NOTICE OF DECISION

**CONDITIONAL USE / CLASS 3 DESIGN REVIEW / CLASS 3 SITE PLAN
REVIEW / CLASS 2 DRIVEWAY APPROACH PERMIT / CLASS 2 ADJUSTMENT
CASE NO. CU-DR-SPR-DAP16-06**

APPLICATION SUMMARY: A consolidated application for a Conditional Use Permit, Design Review, Site Plan Review, Driveway Approach Permit, and Class 2 Adjustment to allow for the development of a proposed 84-unit multiple family development on property located at 3271 Lancaster Drive NE.

HAROLD DRIVE APARTMENTS

REAR ELEVATION (BLD. 1 + 3)
SCALE: 1/8" = 1'-0"

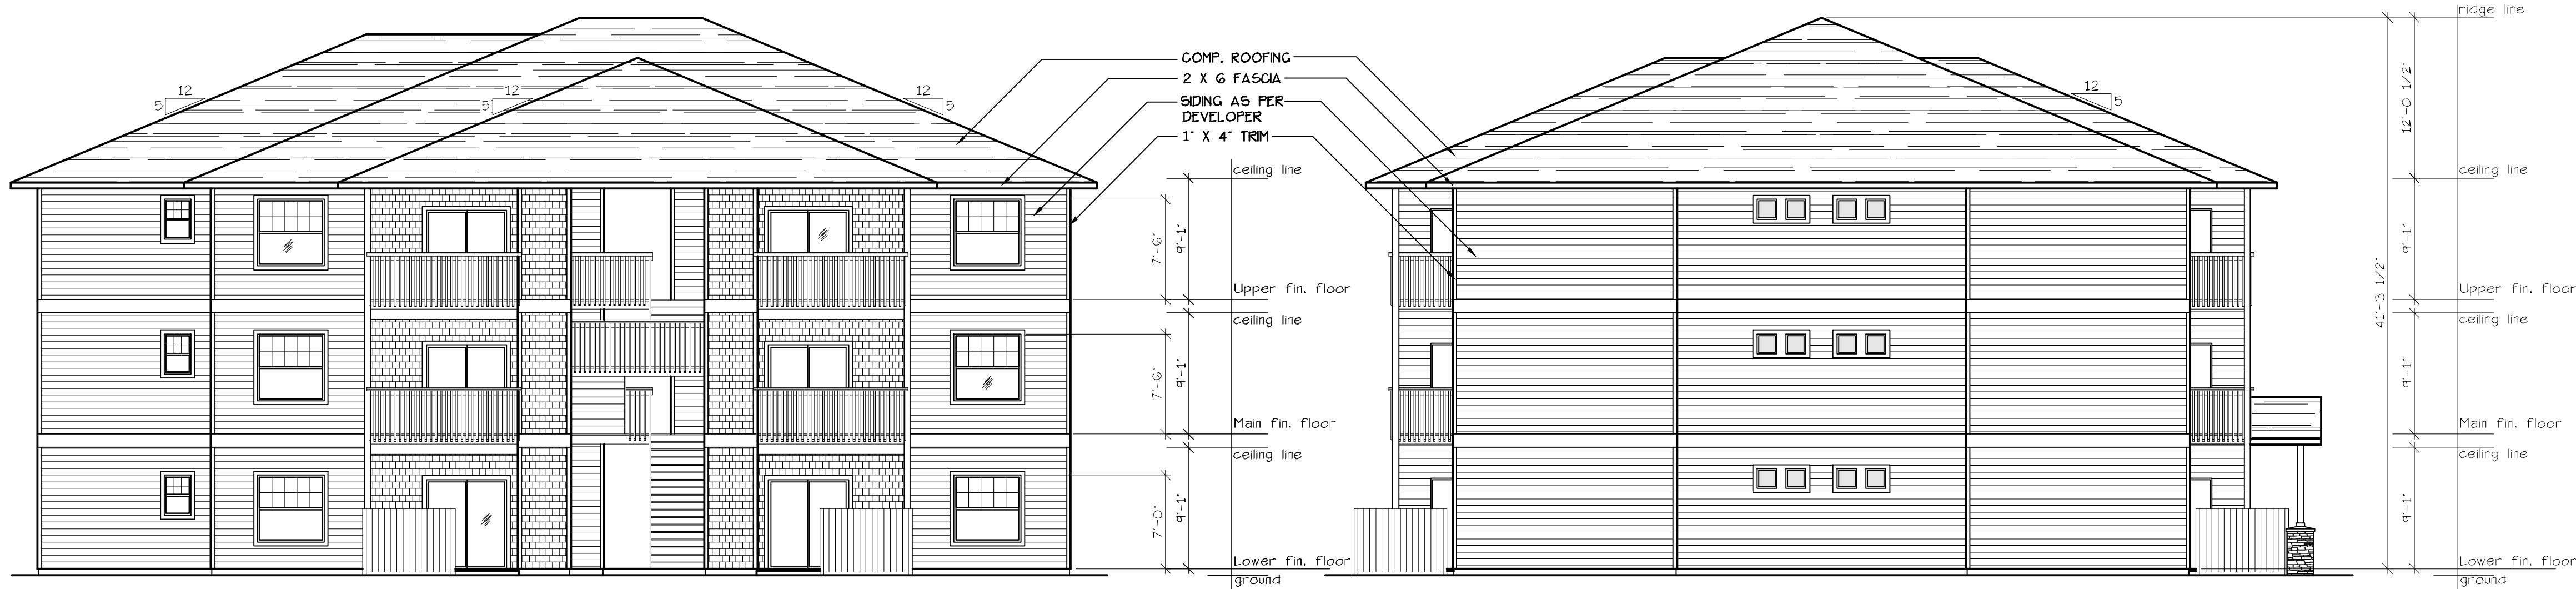
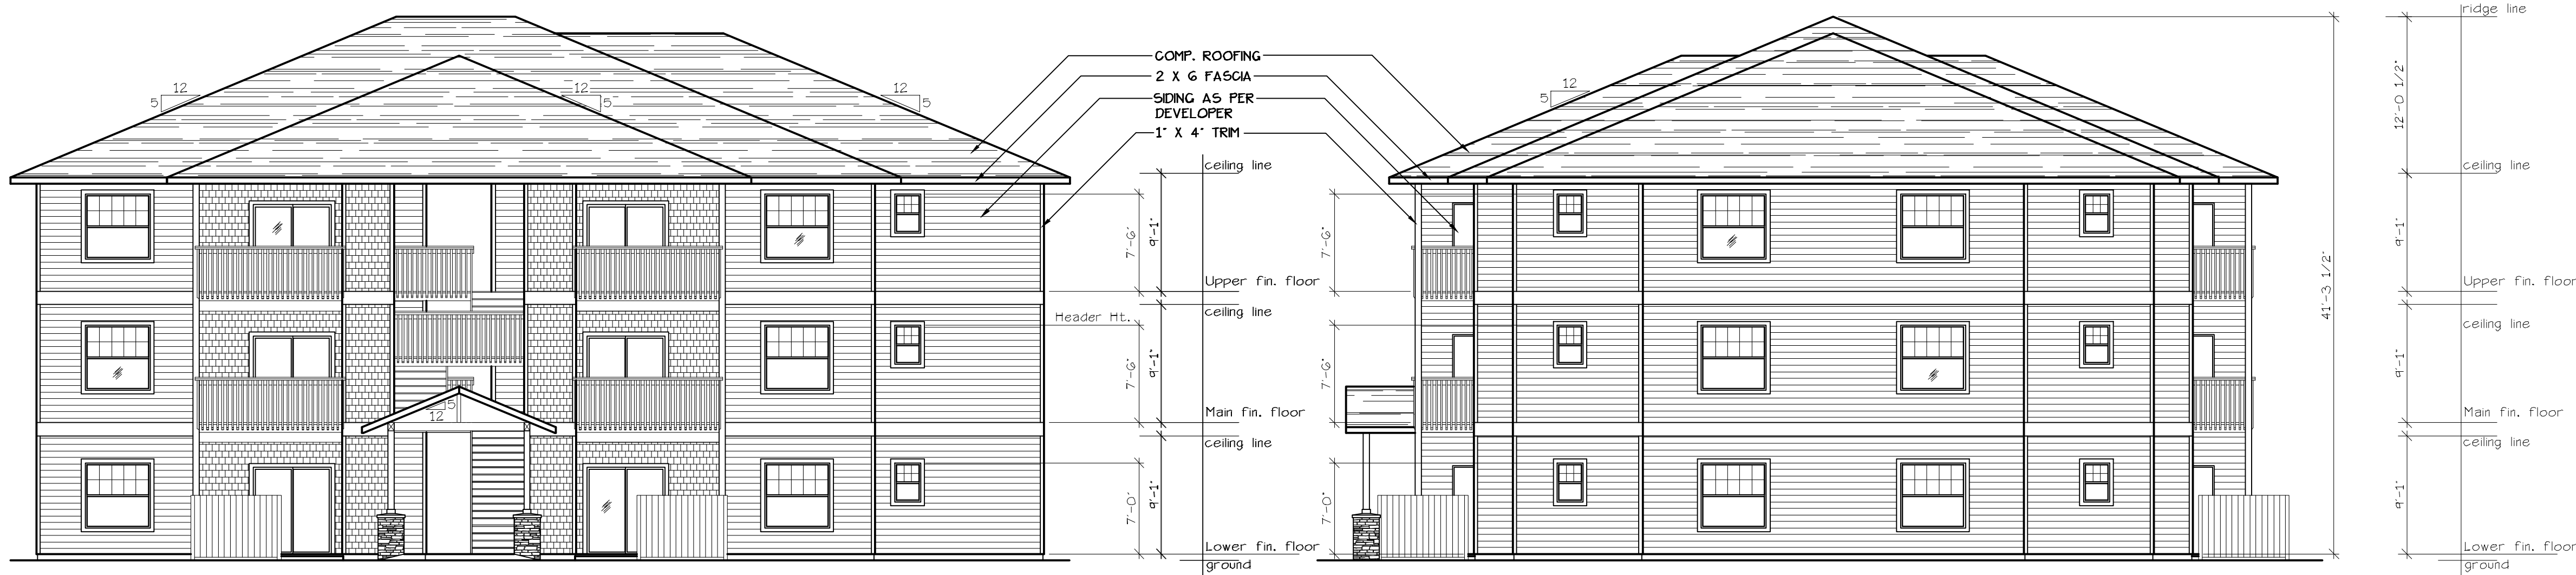
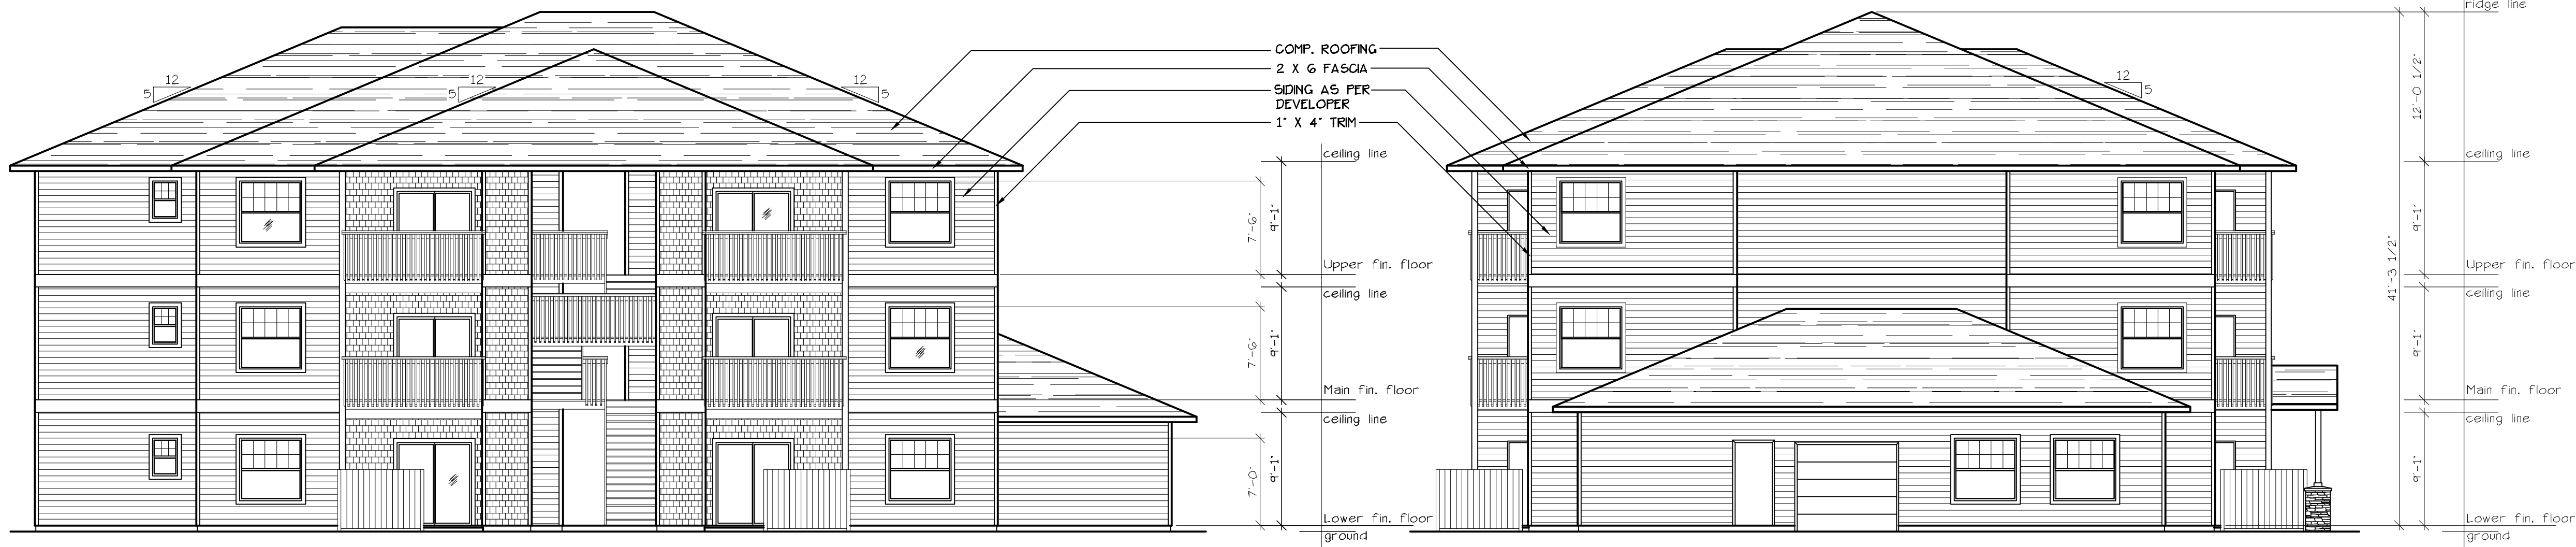
Condition 7: The facades of Buildings 1, 2, and 3 shall be revised to incorporate additional windows as follows:
